Levy Nuclear Plant, Units 1 & 2

COL Application

Technical Specifications

Section A. PSTS and Bases Differences from the DCD GTS and Bases (LNP COL 16.1-1)

FIGURE 4.1-1 Site and Exclusion Boundaries

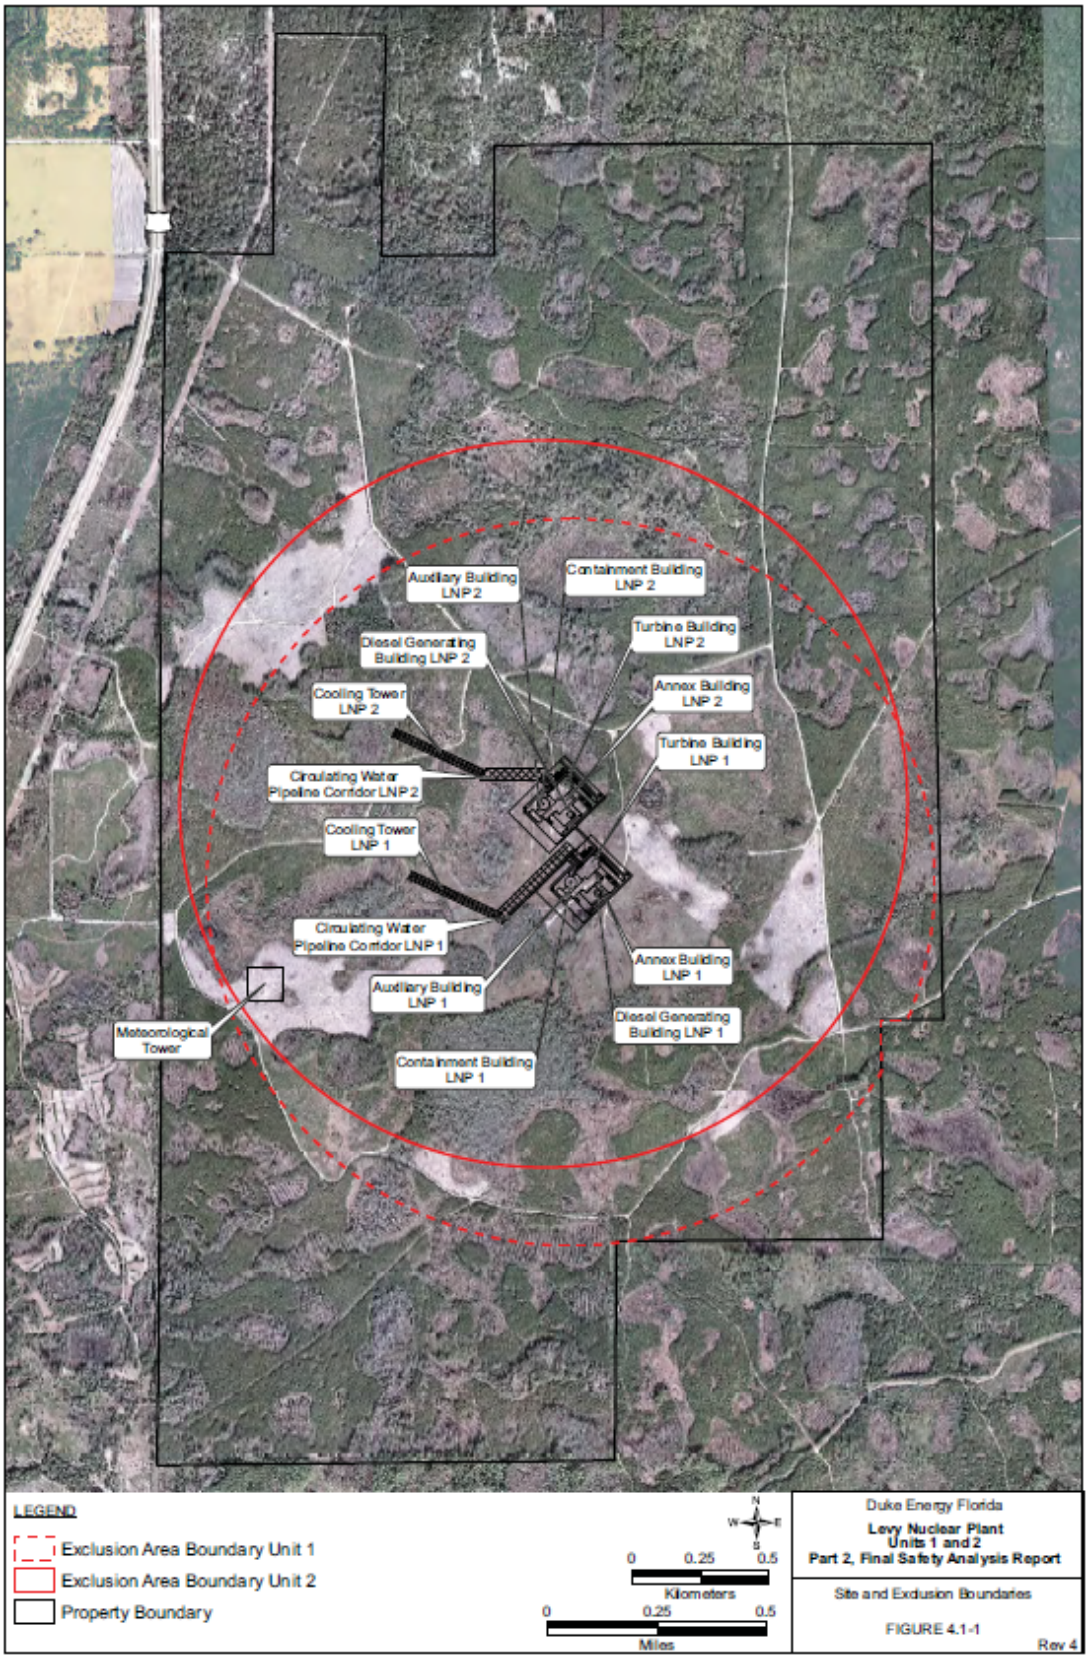
GTS 4.1.1 The bracketed information in the GTS reads:
[This information will be provided by the combined license applicant.]

The Site and Exclusion Area Boundaries are shown in Figure 4.1-1.

Justification:
Bracketed information is replaced to establish Site Boundary and Exclusion Area Boundary for LNP consistent with the descriptions identified in FSAR Sections 2.1.1.2 and 2.1.1.3.

FIGURE 4.1-2 Low Population Zone (LPZ)

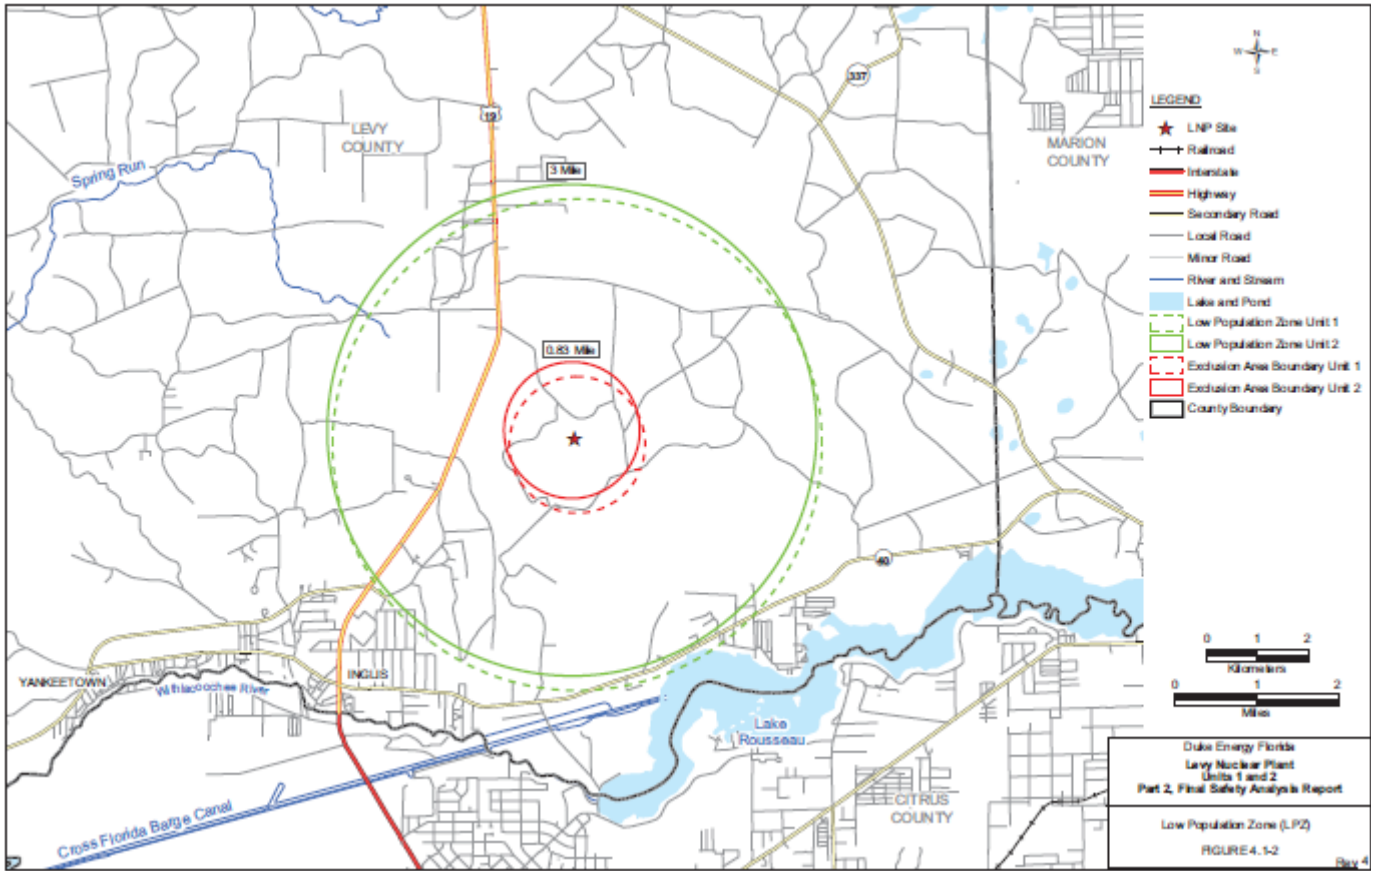
GTS 4.1.2 The bracketed information in the GTS reads:
[This information will be provided by the combined license applicant.]

Replace the bracketed information in the GTS with the following:
The LPZ is defined by the 3 mile radius from the site center point as shown in Figure 4.1-2.

Bracketed information is replaced to establish the LPZ for LNP consistent with the descriptions identified in FSAR Section 2.1.3.4.

Figure B 3.6.8-1 (page 1 of 1)
Time Prior to Coolant Inventory Boiling

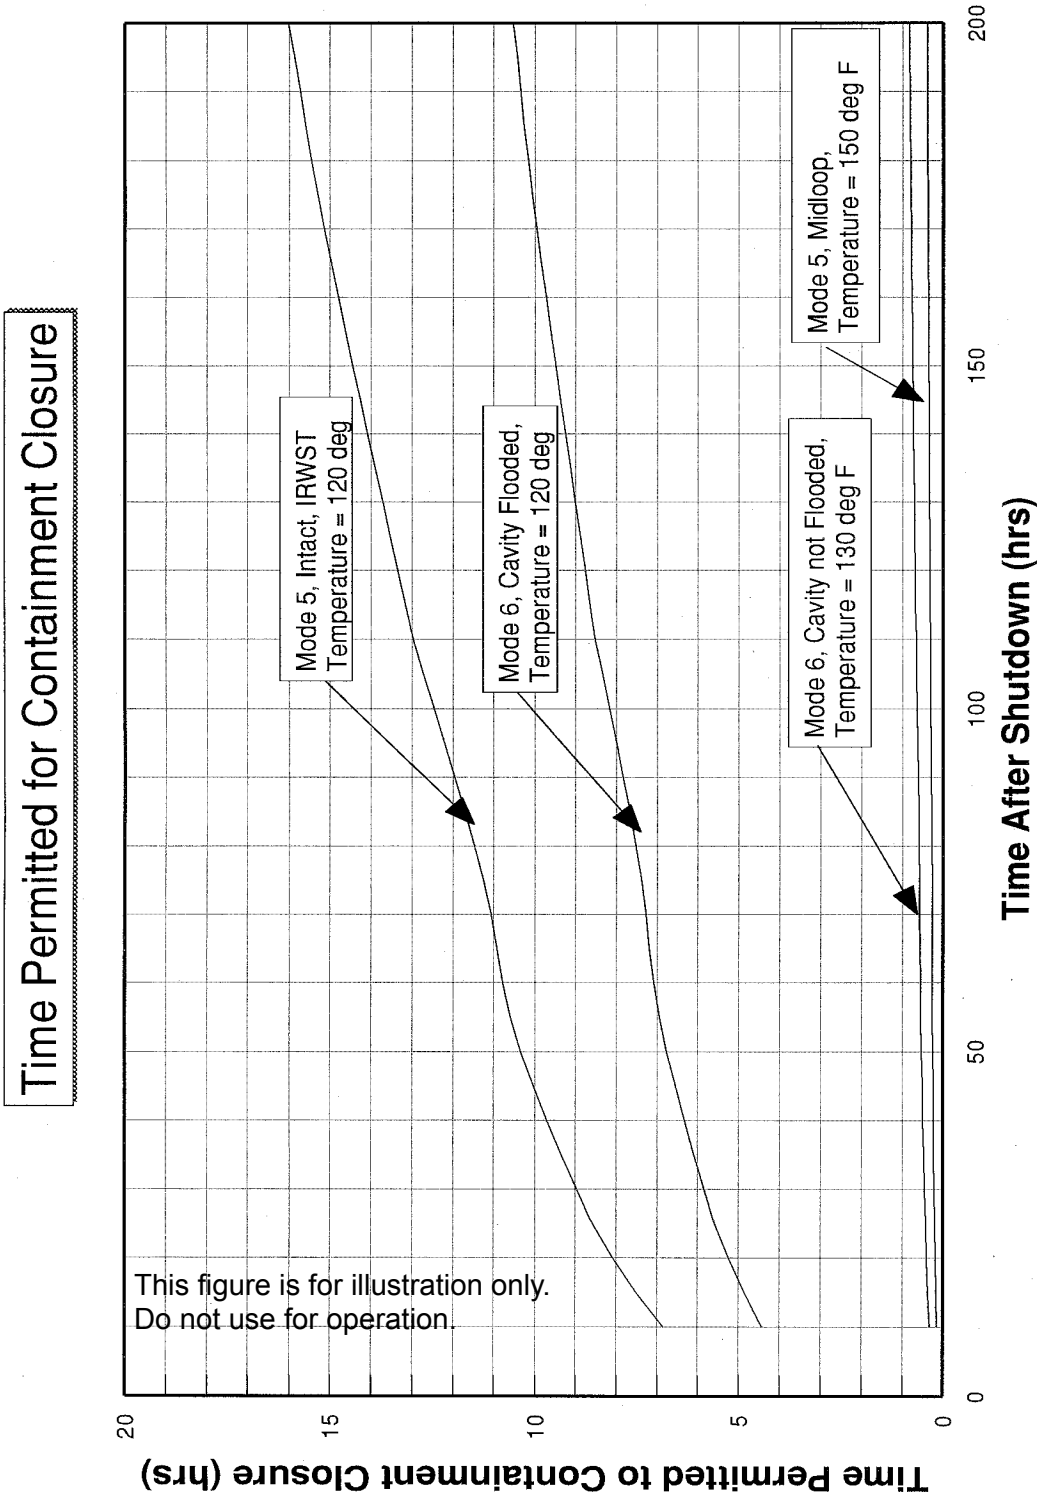
GTS B3.6.8 The Bases for Specification 3.6.8 contain a bracketed figure which addresses the anticipated time prior to coolant inventory boiling under various conditions.

Remove the reviewer note in the PSTS. There is no replacement language.
